Office Action Summary

10/516,447

BEN-HORIN, RAANAN

DETAILED ACTION

(marked Baker Figure 2)

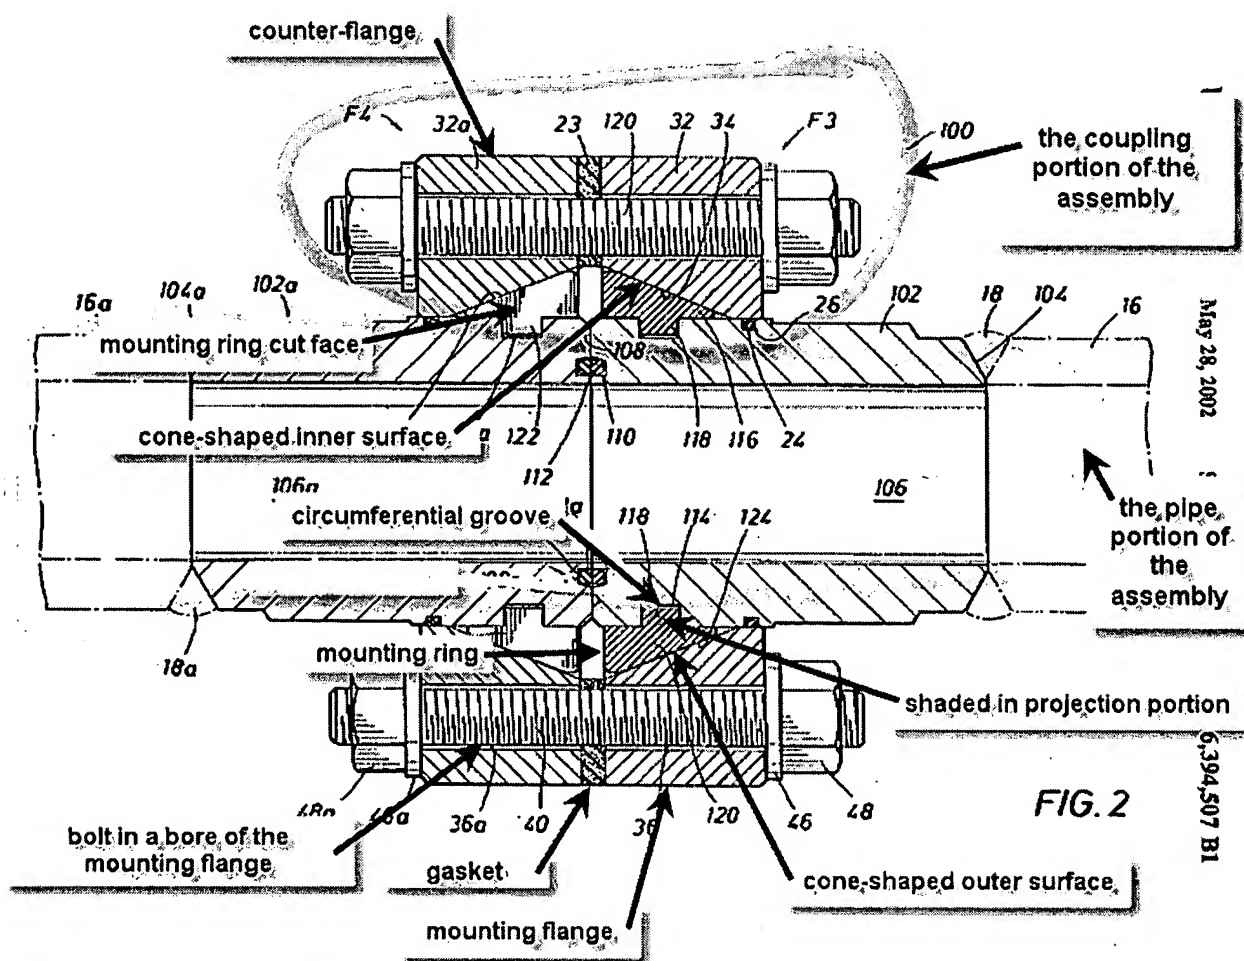
3. Claims 21-23, 26, 31, 32, 34, and 35 are rejected under 35 U.S.C. 103(a) as being unpatentable over Baker (U.S. 6,394,507).
4. In regard to claim 21, Baker discloses in Figure 2, below, a pipe coupling for connecting a pipe (16) to a counter-flange associated with another pipe (16a) in a sealed manner, wherein the pipe is formed with a circumferential groove, the coupling comprising a single gasket, a mounting ring, and a mounting flange having a coned shaped inner surface, wherein the mounting ring is elastically expandable (a material suitable for the mounting ring will have elastic properties) and is integrally formed with an outer cone-shaped surface (as observed in marked Figure 2 below and column 9, lines 29-31 and lines 39-43) and with an inner rib (shaded area as observed in marked Figure 2 below), the rib being adapted to fit into the groove upon elastically expanding the ring over the pipe (column 9, lines 30-38) to hold the ring affixed to the pipe when being tightened towards the counter-flange.

5. Baker discloses the claimed invention except for specifically stating that the mounting ring is resilient. The Examiner notes that metal rings and C-shaped structures generally exhibit at least some resilient quality due to the combination of metal's elasticity and the shape. However, it would have been obvious to one having ordinary skill in the art at the time the invention was made to make the mounting ring out of a resilient material to make the mounting ring resilient, such as spring steel, to reduce permanent warpage of the mounting ring while in storage prior to use and reduce loss of shape during mishaps (which could render the mounting ring useless for installation purposes), since it has been held to be within the general skill of a worker in the art to select a known material on the basis of its suitability for the intended use as a matter of obvious design choice. *In re Leshin*, 125 USPQ 416.

8. Note in regard to claim 21, Baker discloses that his invention need not have gasket 26 with the recitation, starting in column 5, line 66, "Optional O-ring seals 24 and 24a received in annular grooves 26, 26a in conjunction with a gasket 23 (see FIG. 2) disposed between flange faces 33, 33a provide weather-tight sealing of connection apparatus 10." Further, gasket 112 is associated with the pipe portion of the assembly and not the pipe coupling portion of the assembly.

10. In regard to claim 23, Baker discloses that the ring is split by a cut extending in an axial plane thereof (as observed in marked Figure 2, above, the faces of the cuts, part 122, are in a plane with the sectional cut and therefore are made by a cut extending in an axial plane of the mounting ring).

14. In regard to claim 34, Baker discloses that the mounting flange is formed with an inner cone-shaped surface matching the cone-shaped surface of the ring (as observed in marked Figure 2 above).

15. In regard to claim 35, Baker discloses that the mounting flange is formed with a series of bores through which tightening bolts are adapted to pass (as observed in marked Figure 2 above).

(marked Pfefferle Figure 6)

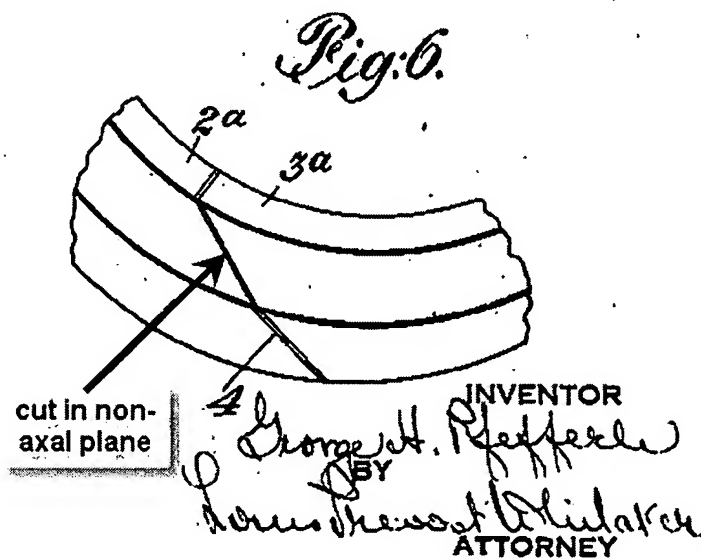
17. In regard to claim 24, Baker discloses the claimed invention except for the ring being split by a cut extending in a non-axial plane thereof. Pfefferle teaches a split ring, in Figure 6 below, used in pipe couplings that is split by a cut (4) extending in a non-axial plane to reduce the tendency of the ring ends from separating when the ring is compressed (column 1, lines 22-33). As the cut ring of Pfefferle relates to joining the ends of split rings, it would have been obvious to one having ordinary skill in the art at the time the invention was made to split the ring of Baker with a cut extending in a non-axial plane as taught by Pfefferle to reduce the tendency of the ring ends from separating when the ring is compressed.

(marked Martin Figure 3)

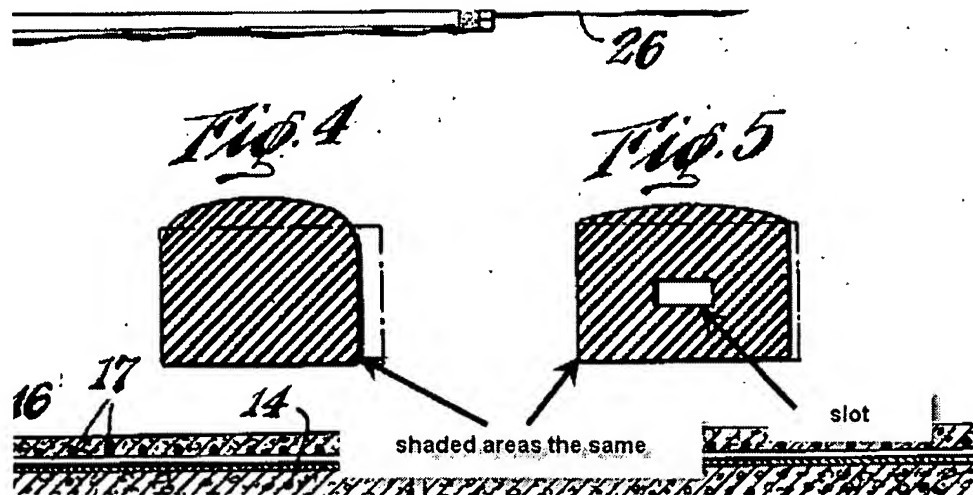
23. In regard to claim 28, Baker discloses the claimed invention except for the mounting ring having a circular recess for the gasket. Martin teaches a pipe coupling with a mounting ring, as observed in marked Figure 3 below, with circular recesses (13) to engage a gasket and improve sealing (column 2, lines 40-44). It would have been obvious to one having ordinary skill in the art at the time the invention was made to modify the mounting ring of Baker with circular recesses as taught by Martin to engage a gasket and improve sealing of the o-ring gasket (23).

24. In regard to claim 33, Baker discloses the claimed invention except for an upright shoulder extending around the end of the cone-shaped surface. Martin, in marked Figure 3 above, further teaches a mounting ring with an upright shoulder (14) to prevent the ring from

(Loth Figure 1 and Figure 2A)

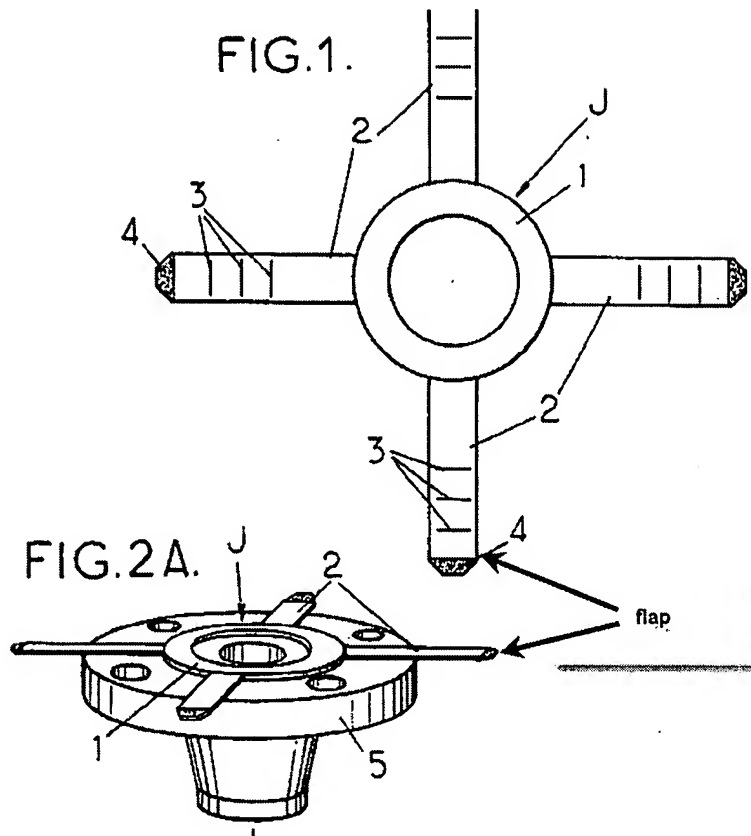
28. In regard to claim 30, Baker in view of Martin and Trickey provide the claimed invention except for the gasket being formed with a thin flap. Loth teaches a gasket in marked Figures 1 and 2A, below, with a thin lip to support the gasket centered prior to assembly of the pipe connection (column 1, lines 63-65). As relates to gaskets, it would have been obvious to one having ordinary skill in the art at the time the invention was made to form the gasket of Baker in view of Martin and Trickey with a thin lip as taught by Loth to support the gasket centered prior to assembly of the pipe connection.

(Milot et al Figure 1)

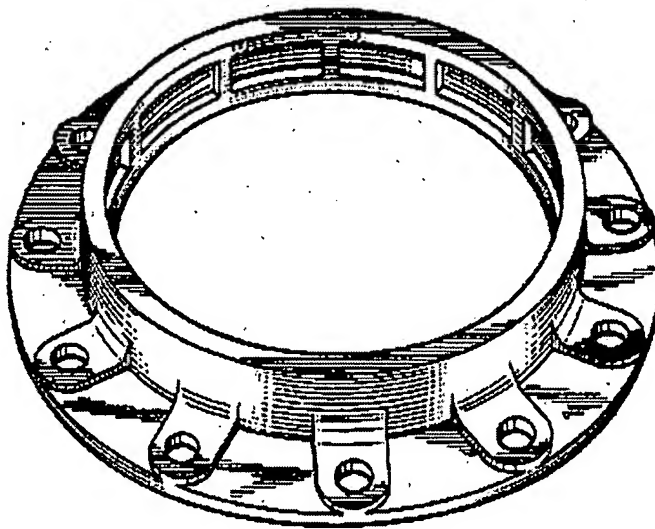
30. In regard to claim 36, Baker discloses the claimed invention except for the series of bores being partly surrounded by arcuate projections. Milot et al teach a flange in Figure 1, below, with arcuate projections partly surrounding the bores to buttress the flange against tensional bending when the bolts are tightened. As relates to flanges, it would have been obvious to one having ordinary skill in the art at the time the invention was made to provide the flange of Baker with arcuate projections partly surrounding the bores as taught by Milot et al to buttress the flange against tensional bending when the bolts are tightened.

(marked Risley Figures 27 and 29)

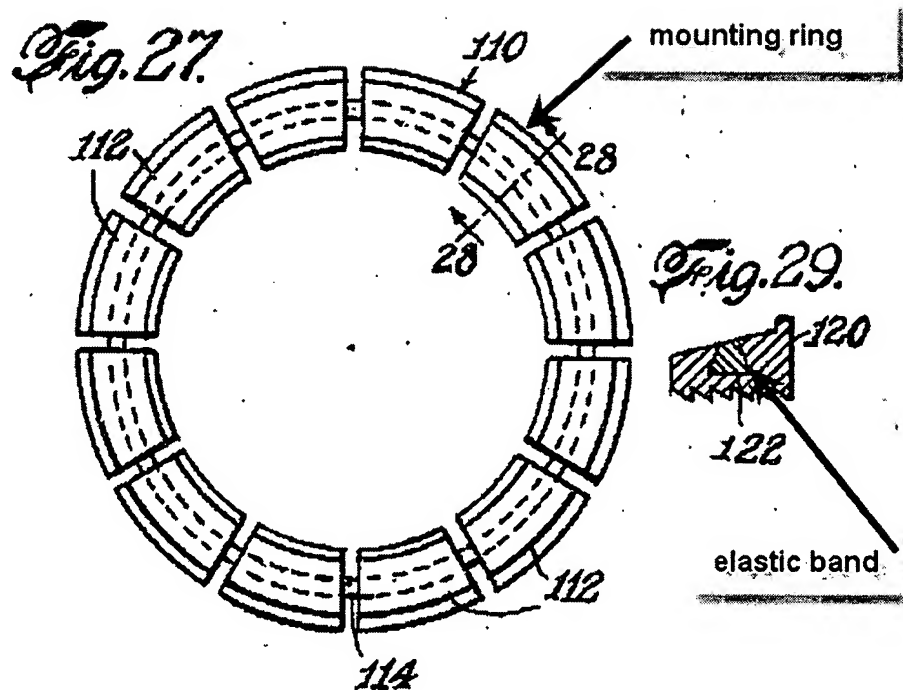
32. In regard to claim 37, Baker discloses the claimed invention except for the ring segments being held together by an elastic band. Risley teaches a pipe coupling with a multi-segment mounting ring in Figure 27, below, with an elastic band (122 as observed in Figure 29. below) holding the segments together to allow the segments to be moved radially inwardly into engagement with the pipe surface when compressed (column 6, lines 33-40). As relates to multi-segment mounting rings, it would have been obvious to one having ordinary skill in the art at the time the invention was made to fabricate the mounting ring of Baker with an elastic band as taught by Risley to allow the segments to be moved radially inwardly into engagement with the pipe surface when compressed.

(marked Seiler Figures 8 and 10)

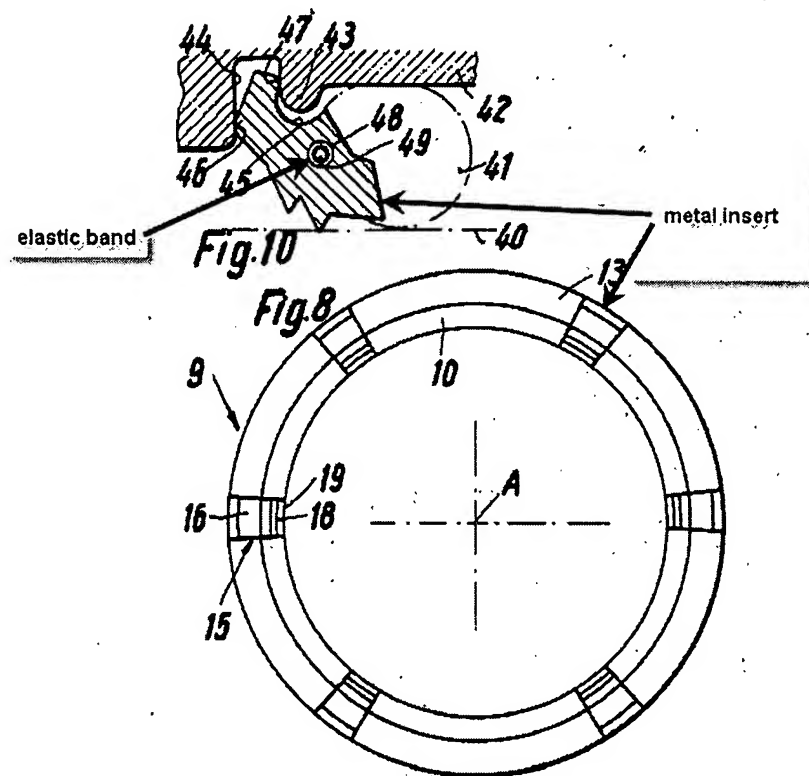
34. In regard to claim 38, Baker in view of Risley provide for the claimed invention except for metal inserts being interposed between adjacent segments. Seiler in Figures 8 and 10, below, teach placing metal inserts (metal as shown by the crosshatching in Figure 8) as an anti-thrust provision in rings of pipe connections to secure the male end against thrust (column 1, lines 1-2, and column 1, line 68, through column 2, line 1). As relates to pipe connection rings, it would have been obvious to one having ordinary skill in the art at the time the invention was made to provide the segmented ring as provided by Baker in view of Risley with metal inserts interposed between adjacent segments as taught by Seiler to secure the male end against thrust.

35. In regard to claim 39, Seiler further teaches that the segments and inserts be held together by an elastic band threaded therethrough to secure the metal segments in the ring (column 6, lines 12-26). As relates to pipe connection rings, it would have been obvious to one having ordinary skill in the art at the time the invention was made to hold the segments and inserts of the segmented ring provided by Baker in view of Risley by an elastic band threaded therethrough as taught by Seiler to secure the metal segments in the segmented ring.
